UNITED STATES PATENT AND TRADEMARK OFFICE

APPLICATION NO.	· FILING DATE	FIRST NAMED INVENTOR	ATTORNEY DOCKET NO.	CONFIRMATION NO.
10/573,627	03/28/2006	Heiko Roehm	3582	5660
Striker Striker	7590 08/03/200 & Stenby	7	EXAMINER	
103 East Neck Road Huntington, NY 11743			DIAO, M BAYE	
nuntington, iv	1 11/43		ART UNIT	PAPER NUMBER
			2838	
	•			
		,	MAIL DATE	DELIVERY MODE
	•		08/03/2007	PAPER .

DETAILED ACTION

Fig. 1

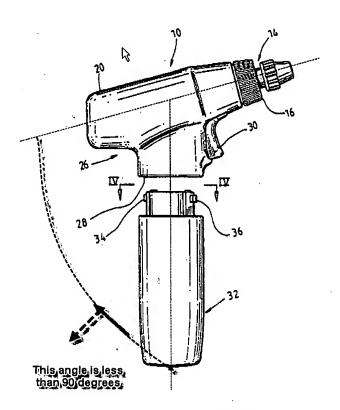
Kilmer discloses () and shows in Figs. 8 – 10, a charger shell (60) having embedding means (32',62,64) on its top surface (see Fig. 8) for receiving the portable power tool (10) (col. 2, lines 36+; col. 3, lines 62+; col. 4) which correspond to a copy of its internal angle outer surfaces that are enclosed by the handle (32') (considering the axis of (10) to be the vertical) and the motor housing (casing (20)) and the gear box (18); and that at least one of the embedding means (32') extends at an angle of less than 90° to the vertical (see Figure 1 below).

As per claim 6, Kilmer further discloses (col. 2, lines 37+; col. 3, lines 62+) and shows in Figs. 1-2 & 8-10, the portable power tool (10) having the handle (32) or (32') (see col. 1, lines 59-60) is used by inserting the battery pack (32) in opening (28) in casing (20) of the portable power tool (10) by twisting motion so as to cause the ears (34) and (36) to engage in slots (38) and (40). The power tool (10) has a trigger switch (30) which acts as an ON/OFF button not into the embedding means (32,62,64) but adjacent to them (see Fig. 1). Kilmer further discloses (see Figs. 1 & 8) the battery and handle (32) protruding from the charger shell (62) and dips only minimally (see Fig. 8)

and the thickness of charger shell (60) compared to the height of the battery pack and handle (32)) into the embedding means.

Therefore it would have been obvious to one of ordinary skill in the art at the time the invention was made since the Applicant has no support data, which convinces that the particular claimed configuration is significant or is anything more than one of numerous configurations a person of ordinary skill in the art would find obvious for the purpose of providing mating surfaces. In re Dailey 149 USPQ 47, 50 (CCPA 1966). See also Glue Co. v. Upton 97 US 3,24 (USSC 1878).
